APP-GW-GLR-097 Revision 0 (Non-Proprietary)

July 2010

**Evaluation of the Effect of the AP1000™ Enhanced Shield Building Design  
on the Containment Response and Safety Analyses**

Figure A-7: Proposed Changes To DCD Figure 6.2.1.1-8

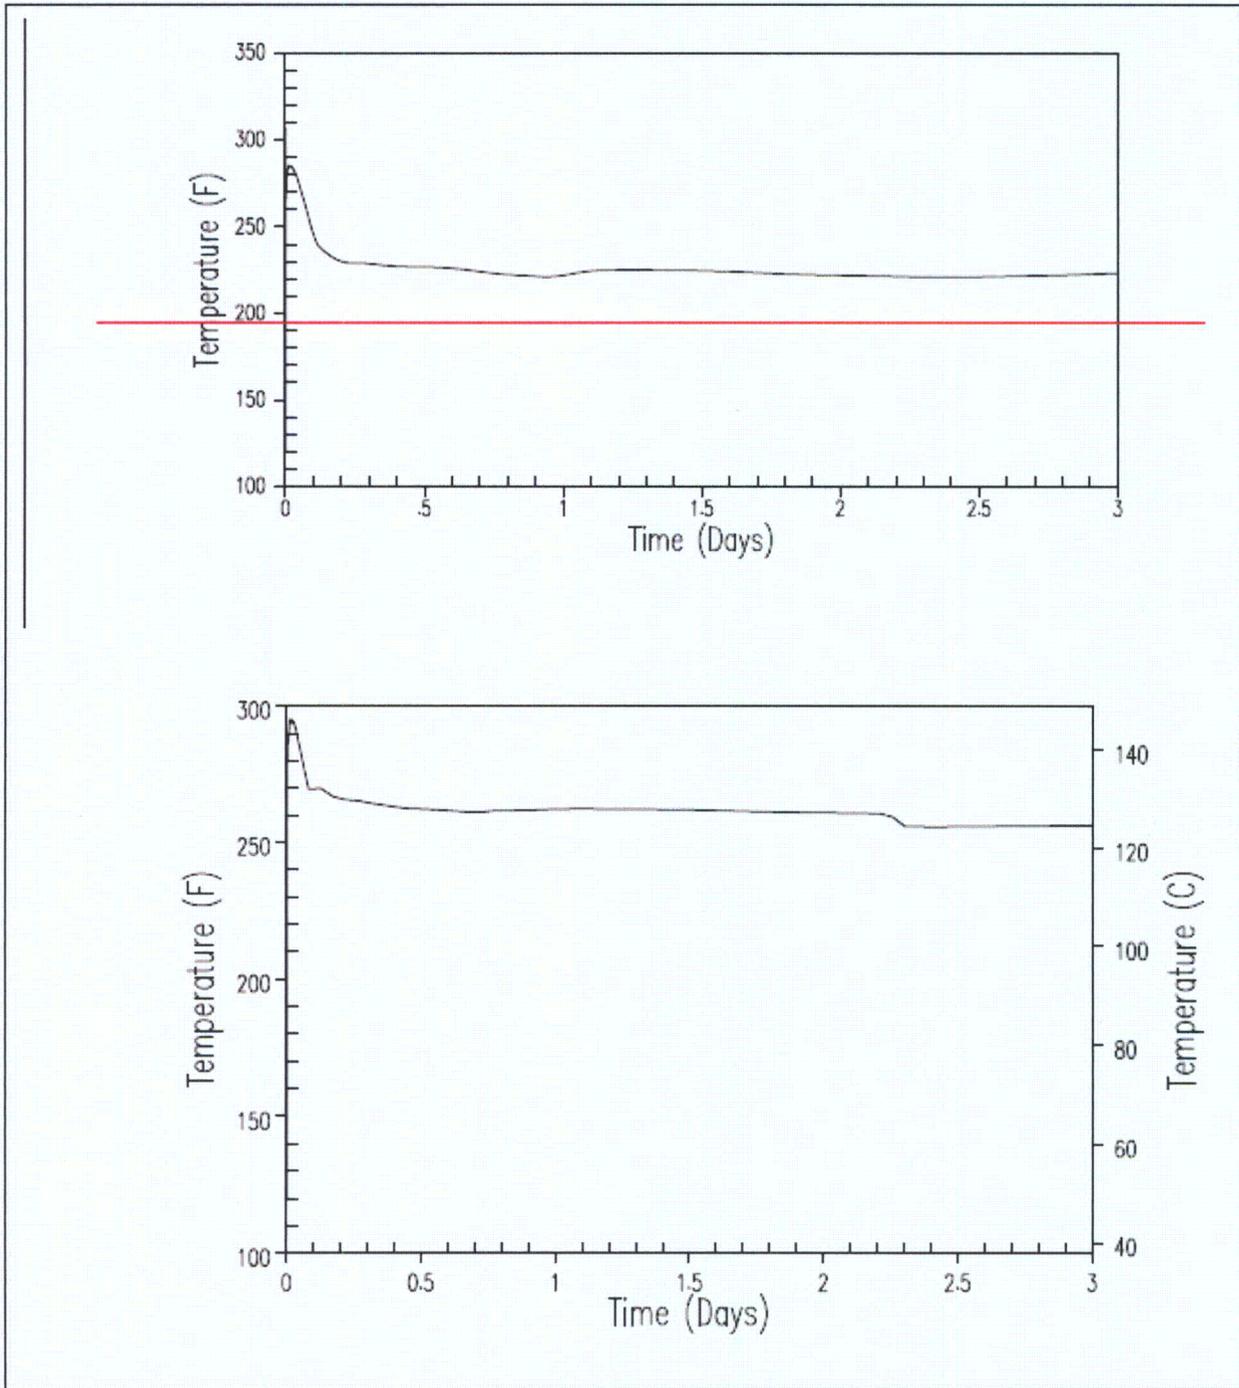
The changes reflected in the enhanced shield building design do not significantly impact the design basis and beyond design basis safety analysis, but they do have a substantial impact on the AP1000 design, as documented in DCD Rev. 17. These design impacts are mostly concentrated in the PCS, Spent Fuel Pool (SFS) system, and the Technical Specifications. This appendix will specify the required DCD markups and associated change descriptions for the above mentioned DCD sections.
